From: Howard, Leslie Ann CIV USN BRAC PMO SAN CA (USA)
[leslie.howard@navy.mil]
Sent: Monday, June 22, 2020 5:07 PM
To: Stoick, Paul T CIV USN (USA) [paul.stoick@navy.mil]
Subject: RE: E-2 RACR RTCs
Attachments: RTC – D_RACR_Parcel E-2_r1F.pdf

Response to Comments on the Draft Remedial Action Completion Report, Parcel E-2 Phase II, Hunters Point Naval Shipyard, San Francisco, California, December 2019, DCN: APTM-2005-0013-0047

Comments by: Nina Bacey, California Department of Toxic Substances Control, comments dated March 5, 2020

- *Core Boring Logs C2 to C6 are believed to represent the approximate location of the Upland Slurry Wall alignment*

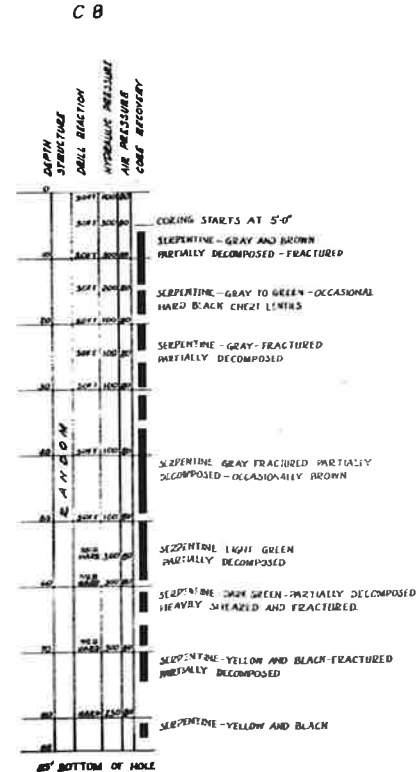
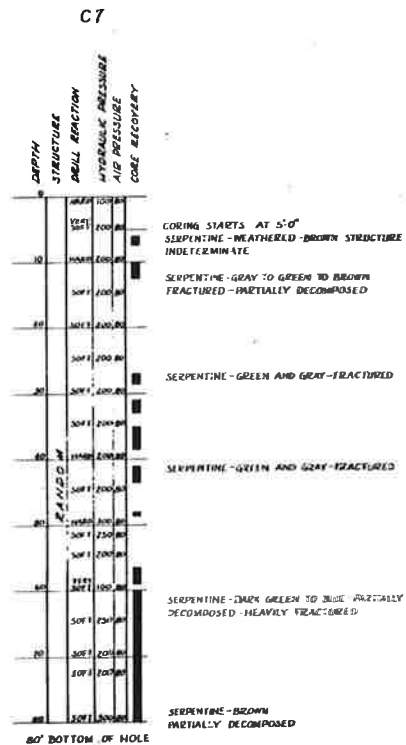
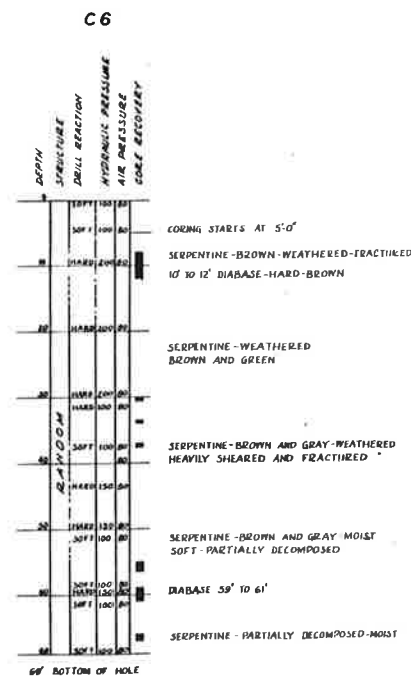
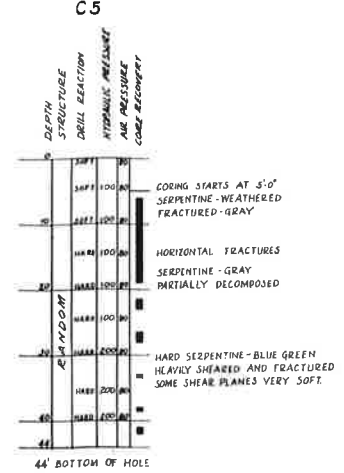
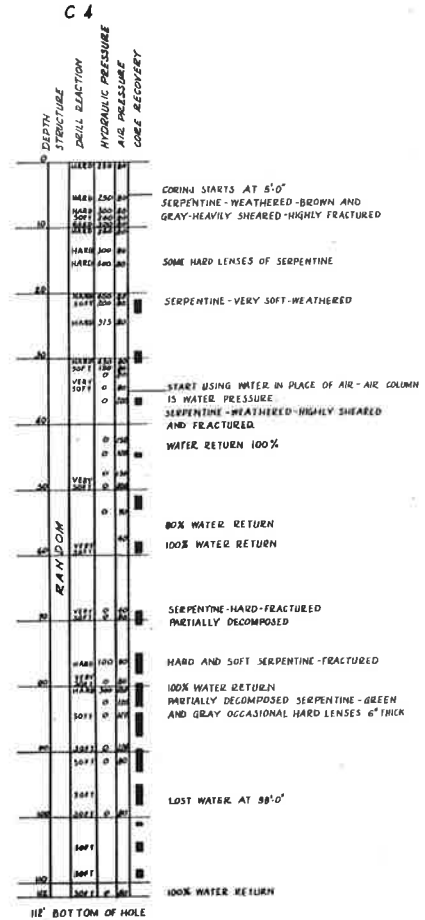
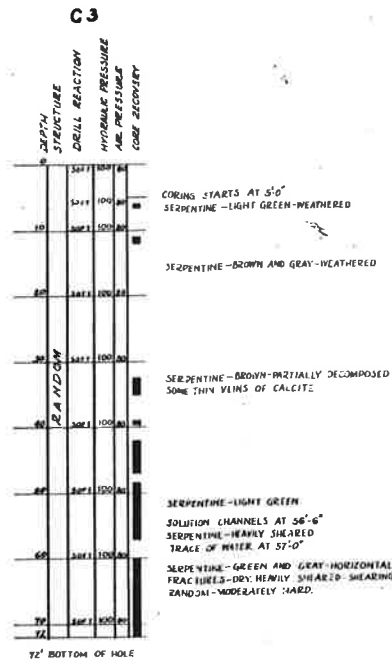
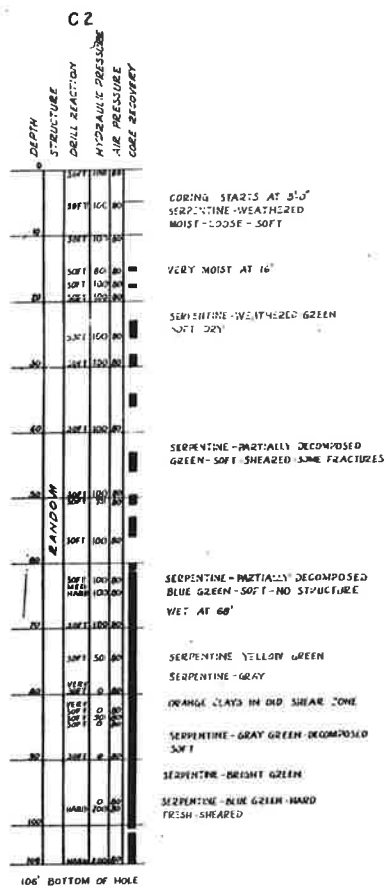
<p>15. Section 3.2.14, Upland Slurry Wall Installation and Section 4.2, Upland Slurry Wall and French Drain</p> <p>The Phase II RACR concludes that the 220-foot gap in the Upland Slurry Wall results from “a distinct layer of serpentine weathered bedrock encountered approximately 10 feet bgs in the northwestern corner of the Parcel E-2 site.” After completion of a subsurface investigation involving 12 borings and a review of “boring logs from historic documentation within the area,” the Phase II RACR concludes that serpentine weathered bedrock was the “buried obstruction” that impeded upland slurry wall construction.</p> <ul style="list-style-type: none"> a. Provide the boring logs and other relevant data from the 12-boring step-out investigation of the “buried obstruction,” supporting the conclusion that serpentine weathered bedrock was the buried obstruction that impeded Upland Slurry Wall installation. b. Provide the boring logs from historic documentation within the area, supporting the conclusion that serpentine weathered bedrock was the buried obstruction that impeded Upland Slurry Wall installation. 	<ul style="list-style-type: none"> a. Formal boring logs were not prepared as part of the direct-push drill rig investigation described under Section 4.2 of the RACR. The step-out investigation was only intended to confirm the presence/absence of the (as of that time, unknown) buried obstruction in relation to the proposed upland slurry wall alignment. As described under Section 4.2, no clear path around the subsurface obstruction was observed. b. Electronic copies of the relevant boring logs from the historic documentation within the area will be provide as part of the Final RACR submittal, as an attachment to this RTC file (Appendix A).
